CITY OF ALBUQUERQUE

RE: **Lot 2 Block 3 Unit 18, S.A.D. 228**
Volcano Cliffs Subdivision
6612 Cuervo Pl. NW
Grading and Drainage Plan
Engineers Stamp Date; 10-29-19 (D10D003S2)
Pad Certification Date; 11/20/19

RE: **Lot 2 Block 3 Unit 18, S.A.D. 228
Volcano Cliffs Subdivision
6612 Cuervo Pl. NW
Grading and Drainage Plan
Engineers Stamp Date 10/28/19 (D10D003S2)**

JOHNSON (MIKE SANCHEZ) - 6612 CUERVO GRADING & DRAINAGE PLAN

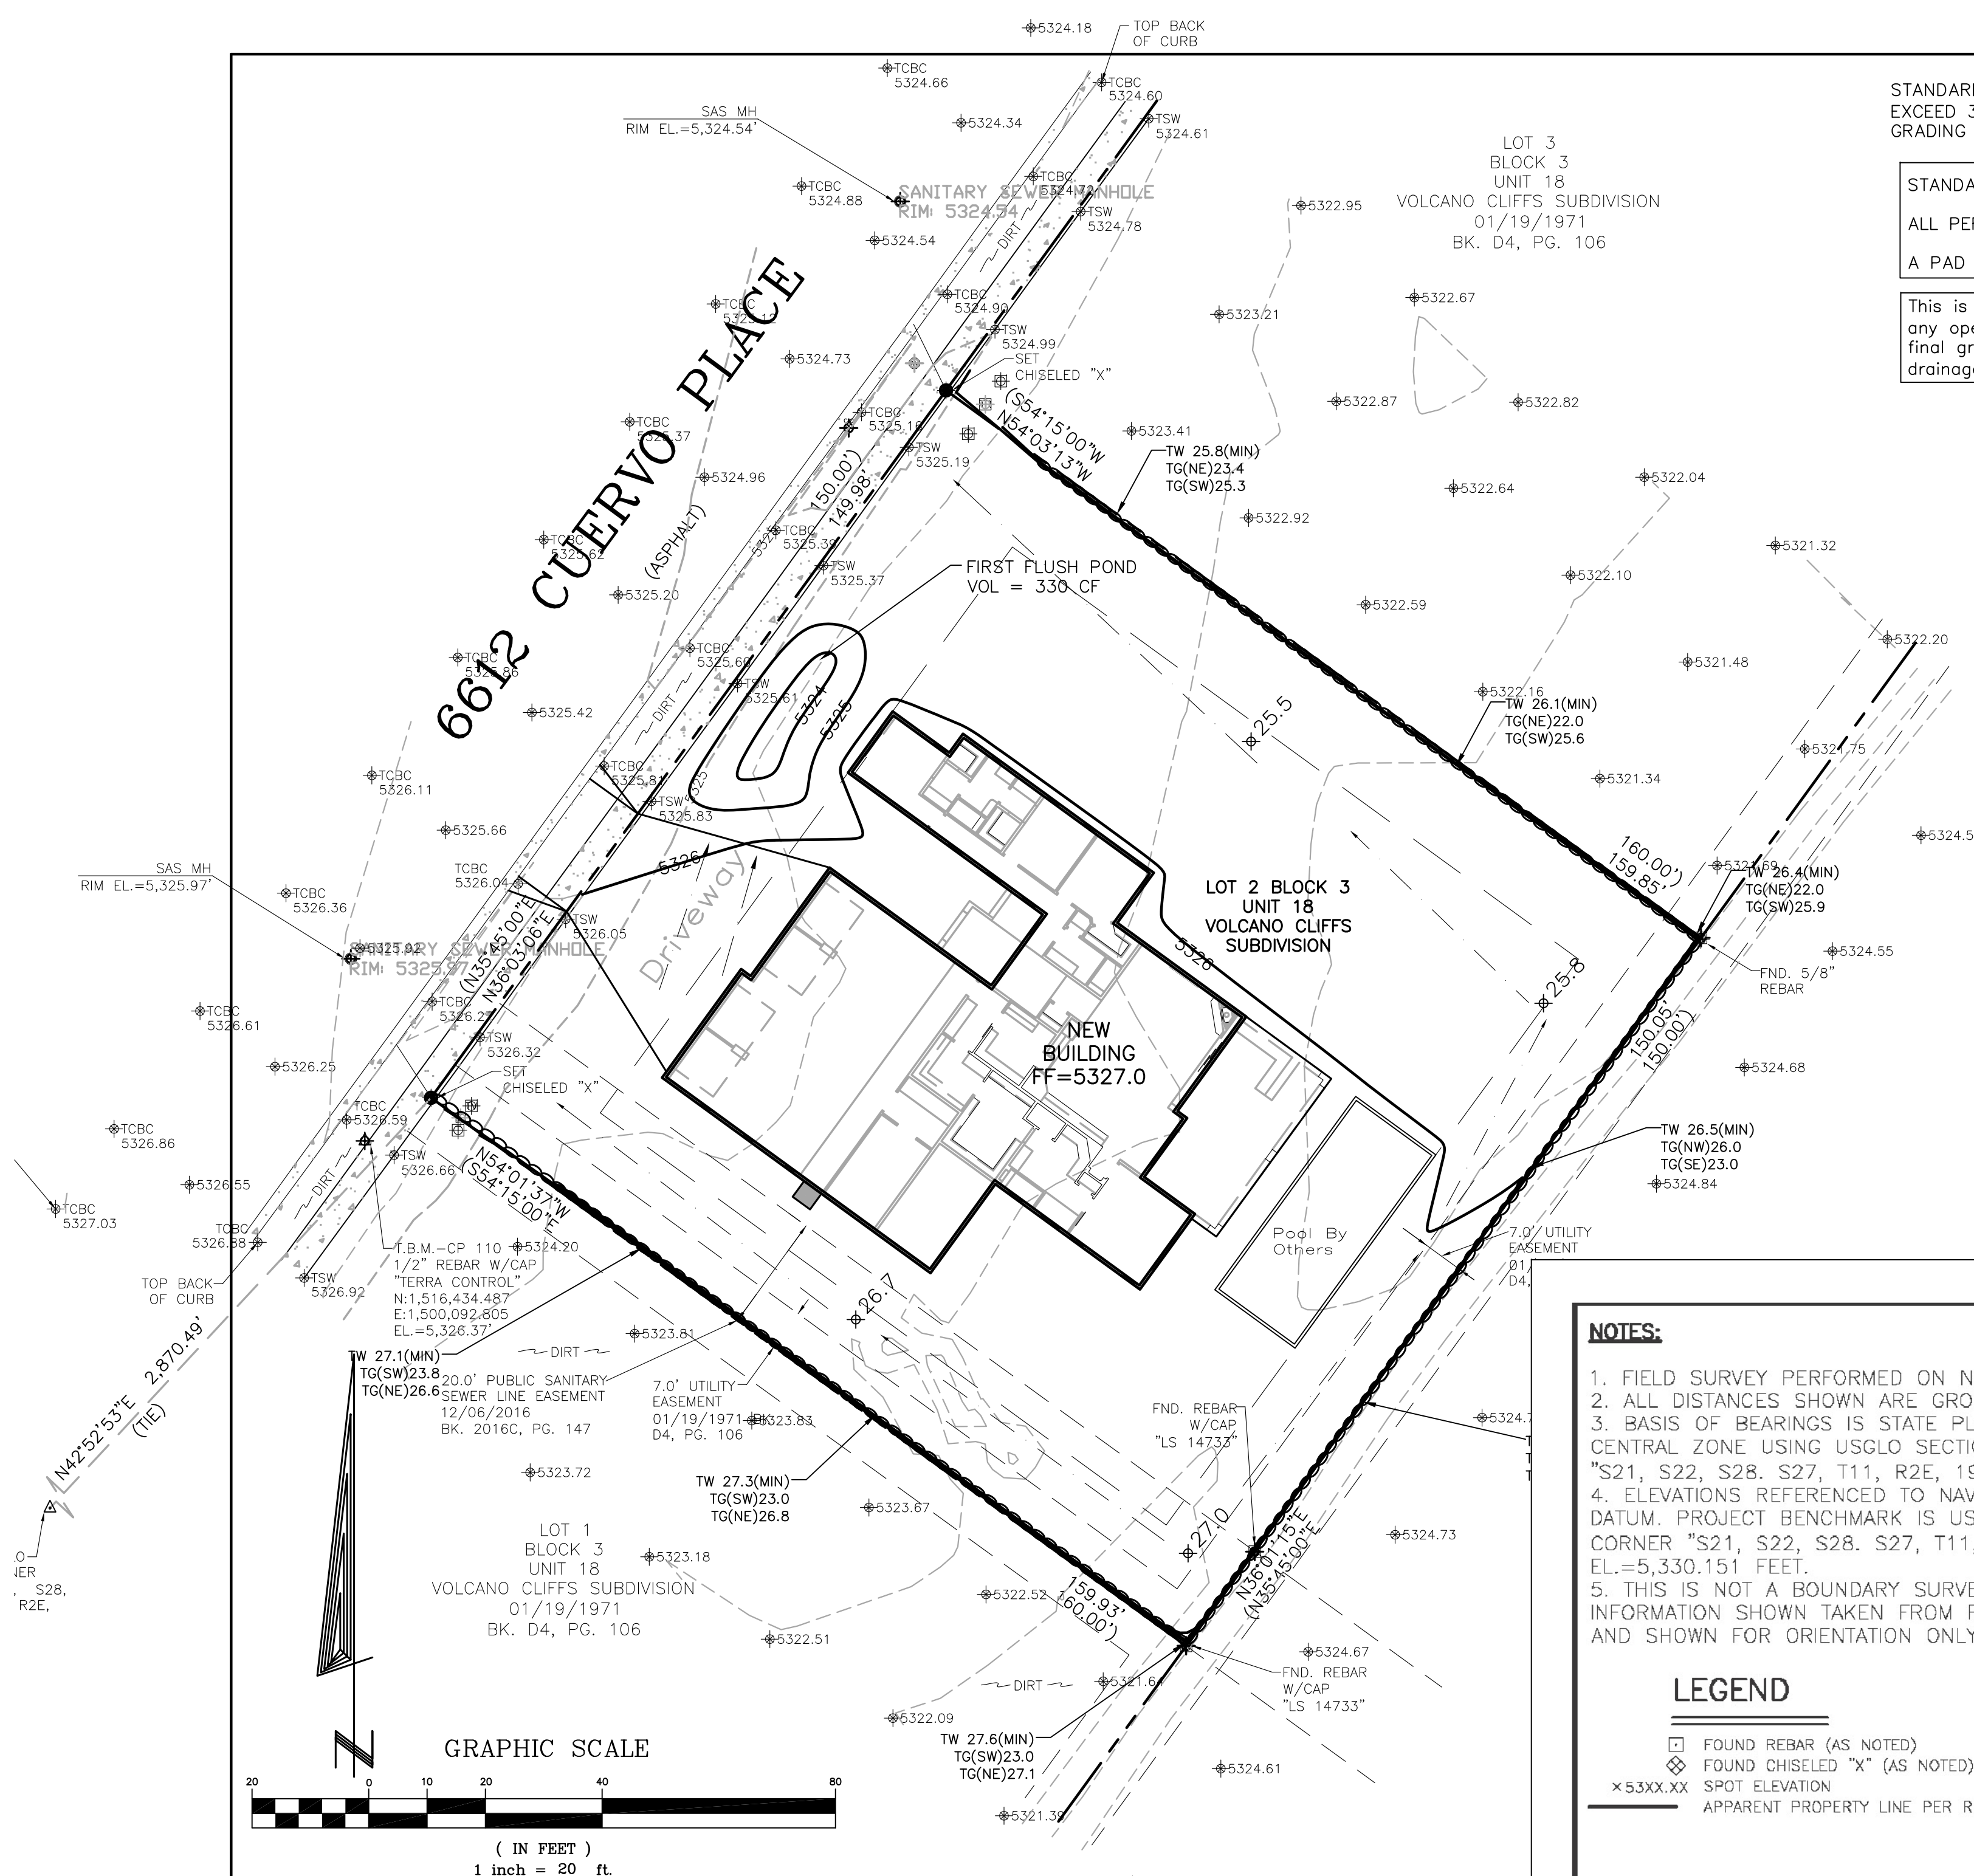
Based upon the information provided in your submittal received 11/20/19, this plan is approved for Building Permit.

Please have the owner/builder attach a copy of this approved plan, to the construction sets in the permitting process prior to sign-off by Hydrology.

Prior to Certificate of Occupancy release, Engineer Certification per the DPM checklist of this plan will be required.
